# UNITED STATES PATENT AND TRADEMARK OFFICE

10/737,355

Brent R. Jones

<b>Office Action Summary</b>	<b>Application No.</b>	<b>Applicant(s)</b>	
	10/737,355	JONES, BRENT R.	
	<b>Examiner</b>	<b>Art Unit</b>	
	Leonard S. Liang	2853

FIG. 4

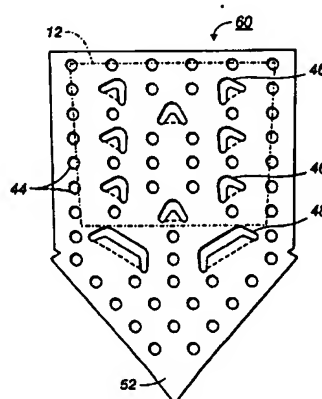
- {claim 1} A drip plate for use in a phase change ink jet printer using solid ink, comprising: an upper portion; and a lower pointed portion, wherein the lower portion is not coplanar with the upper portion (figure 4; column 6, lines 65-67)

- {claim 12} at least one anchor tab extending from the second side of the drip plate located near the center of the plate (figure 4, reference 46)
- {claim 13} wherein the anchor tabs are arranged in pairs and wherein each pair is arranged substantially symmetrically about a vertical center line (figure 4, reference 46)

- {claim 14} a silver strainer located near a lower edge of the drip plate (figure 4, reference 48)
- {claim 15} An ink loader (figure 3)
- {claim 16} An ink loader for a phase change ink printer (figure 3), comprising: at least one channel having an entry end and an exit end (figure 3, reference 25A-D); a melt assembly, which includes a drip plate including an upper portion

FIG. 3

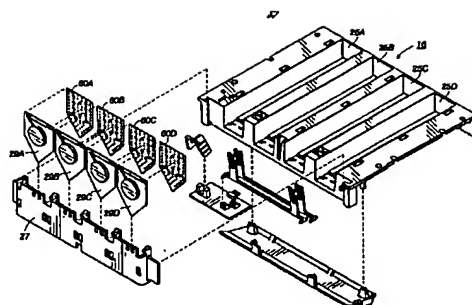
- {claim 2} wherein a heating element is bonded to a first side of the upper portion (figure 3, reference 29A-D)

- {claim 3} wherein the heating element is a closed loop heater (figure 3, reference 29A-D)
- {claim 6} wherein the drip plate is made from metal (column 7, lines 16-17)

having substantially flat upper first and second sides, and a lower portion having substantially flat lower first and second sides, wherein the lower portion is not coplanar with the upper portion (figure 3, reference 60A-D; column 6, lines 65-67); a melt plate fastened to the upper second side of the drip plate; and a heating device thermally connected to one of the melt plate and the drip plate (figure 3, reference 29A-D)

- {claim 17} further comprising an adapter to position the assembly relative to the at least one channel (figure 3, reference 27)
- {claim 18} wherein at least one of the drip plate and the melt plate is made from nonferrous metal (column 7, lines 16-17)
- {claim 19} wherein at least one of the drip plate and the melt plate is made from aluminum (column 7, lines 16-17)
- {claim 23} wherein the heating element is a closed loop heater (figure 3, reference 29A-D)
- {claim 26} wherein the melt plate includes at least one anchor tab extending from the second side of the drip plate (figure 4, reference 46)
- {claim 27} wherein the melt plate includes a silver strainer located near a lower portion of the drip plate (figure 4, reference 48)
